PAP/2025/0155

Response to LLFA Comments

Project Ref: LE25058

Report No: OR-LINK-XX-XX-RP-C-TN02

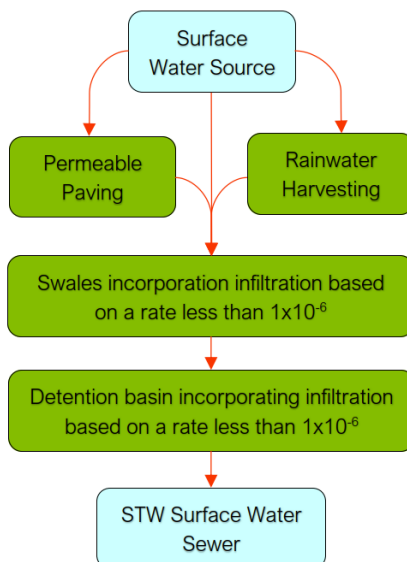
- 2.1. The applicant has highlighted that the proposed outfall will be to an existing STW surface water sewer. Infiltration testing in accordance with BRE 365 will need to be conducted at the next stage of the planning process to clarify whether or not an infiltration type of surface water disposal is suitable.

Infiltration has been considered as the primary method to discharge surface water from the site but was found unviable. Based on the Geo-Environmental Desk Study Report prepared for the site it is understood that superficial Head deposits overlie Helsby Sandstone Formation. Based on review of the publicly available information for the area, including the ground investigation prepared for the adjacent development, it is expected that the granular Head material is only at the top 1m and is underlaid by cohesive strata. This information indicates that a detention basin deeper than 1m is unlikely to be suitable for infiltration. We therefore recommend that infiltration testing is secured by a planning condition; if the tests confirm adequate infiltration rates, the proposed detention basin is to be redesigned as an infiltration basin.
